March 16, 2011

Re: Proposed modifications to Philadelphia's Class B airspace area

Figure 2

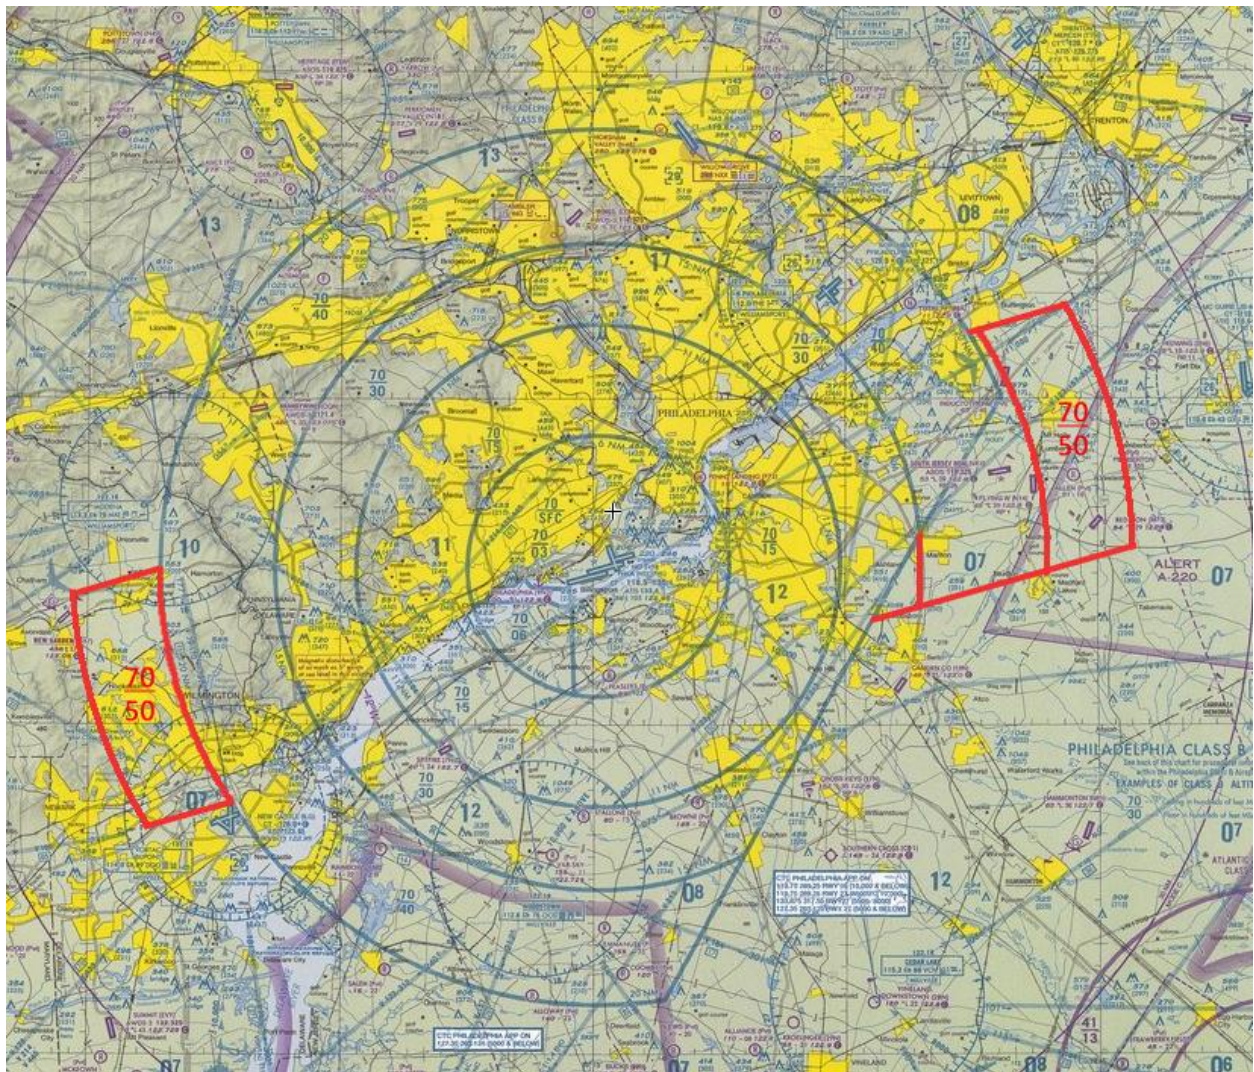
AOPA proposes that the 20-24 nautical mile ring be removed and replaced with Class B extensions extending to the northeast and southwest to contain arrivals currently exiting the Class B in these areas. To further mitigate the impact on VFR operators outside of Class B as well as the USAF use of the Alert Area east of PHL, AOPA requests that the FAA retain the existing easternmost boundary of the PHL Class B until reaching the southern portion of the extension (refer to Figure 2). AOPA's suggested modifications meet the goal of containment within the Class B airspace while minimizing the impact on general aviation traffic and the USAF operations in Alert Area A-220.

The multiple sectors and various floor heights create an overly complex Class B airspace area that pilots will find difficult to transit and which may lead to inadvertent airspace incursions. Portions of the expanded Class B airspace do not appear to serve a containment, safety, or efficiency purpose and should be removed to mitigate the impact on general aviation and USAF operations in Alert Area A-220. The attached figures illustrate AOPA's suggested modifications to the FAA's current design.
